# UNITED STATES PATENT AND TRADEMARK OFFICE

10/788,492

**Office Action Summary**

## DETAILED ACTION

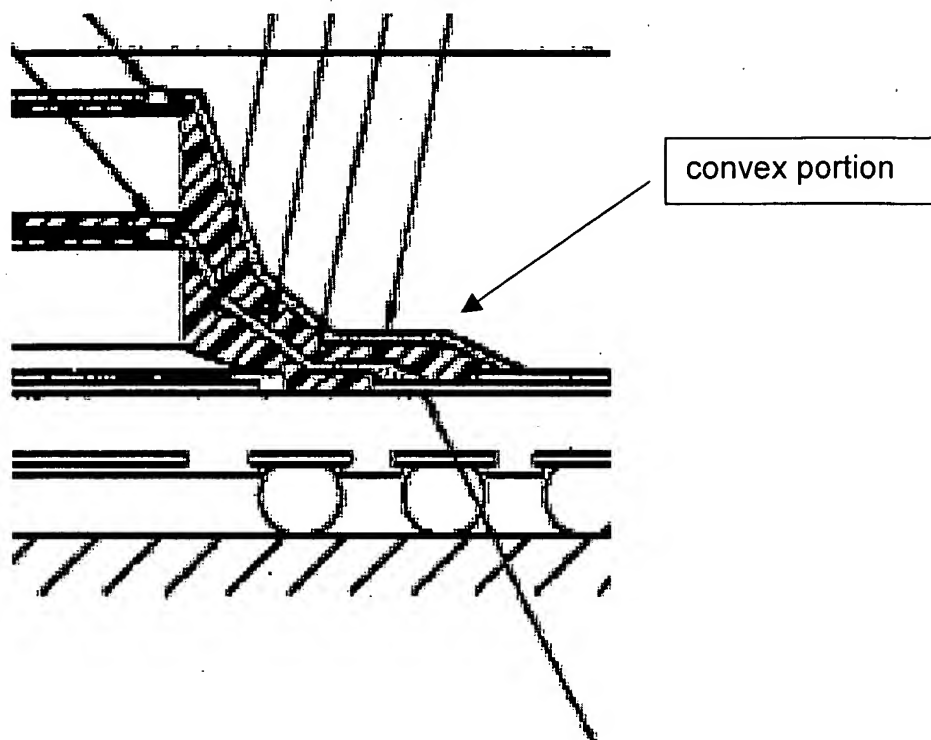
- a metal layer 102 formed on the pad;
  - an insulating section 104b/104c formed adjacent to the chip component 10b, the insulating section having an inclined surface descending in an outward direction from the chip component, the inclined surface being a convex surface that draws a curve on a view from which a cross section perpendicular to the first surface of the chip component is taken (figure 14a shows a view from a cross section perpendicular to the first surface of the chip component, as seen in figure 14a the insulating section has an inclined surface that is convex and draws a curve, this section is shown in figure 14a reproduced below); and

Applicant has argued that Nakanishi fails to teach the inclined surface is a convex surface that draws a curve on a view which is taken from a cross section perpendicular to the first surface of the chip component. This is not persuasive. As explained in the rejection above, the inclined surface that bulges slightly outward (as recognized by applicant in line 12 of page 7 of their response) is a convex surface. The view shown in the figure is taken from a cross section perpendicular to the first surface of the chip component. Thus, the insulating section of Nakanishi reads on that claimed. Applicant further argues that insulating layers 104a, 104b located above substrate contacts 100 (seemingly the same section that forms the convex surface) are not positioned at a location that is at a cross section perpendicular to the upper surface of the die. This is not persuasive. The entire figure 14a is a cross section perpendicular to the upper surface of the die. The claim does not limit the convex surface as being in any particular part of the cross section, or the cross section itself only being a cross section of the area of the chip alone, but rather the claim recites a view from the cross section. Since figure 14a is just such a view, the convex surface shown therein reads on the convex surface claimed.
